2020年11月5日
アドバンテック株式会社

HPC-8シリーズ、モデル変更のお知らせ

この度、安全性規格IEC/UL60950の失効に伴い、HPC-8シリーズサーバシャーシのIEC/UL62368-1対応の電源への変更とそれによる型番の変更を行います。

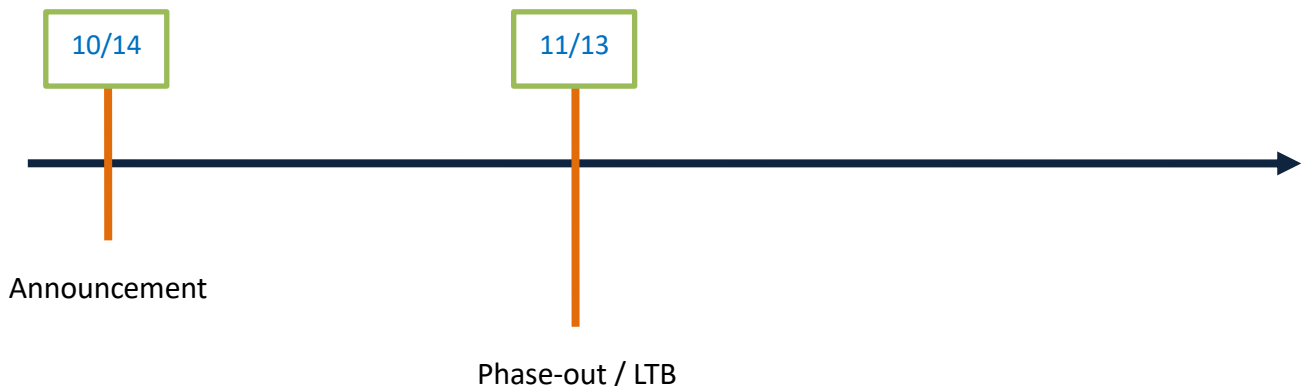
End of Life Product	Suggest Replacement Product	Difference
HPC-8224SA-R5A1E	HPC-8224SE-R8A1E	<ol style="list-style-type: none"> Chassis depth change from 540mm to 620mm PSU change from 550W to 800W
HPC-8316SE-R8A1E	HPC-8316SA-R5A1E	<ol style="list-style-type: none"> Chassis depth change from 620mm to 540mm PSU change from 800W to 550W
HPC-8316TA-00A1E	HPC-8316SA-R5A1E	<ol style="list-style-type: none"> PSU change from empty to default 550W HDD BP change from SATA to SAS version
HPC-8316TE-00A1E	HPC-8316SA-R5A1E	<ol style="list-style-type: none"> Chassis depth change from 620mm to 540mm PSU change from empty to default 550W HDD BP change from SATA to SAS version
HPC-8424SA-R5A1E	HPC-8424SE-R8A1E	<ol style="list-style-type: none"> Chassis depth change from 540mm to 620mm PSU from 550 to 800W
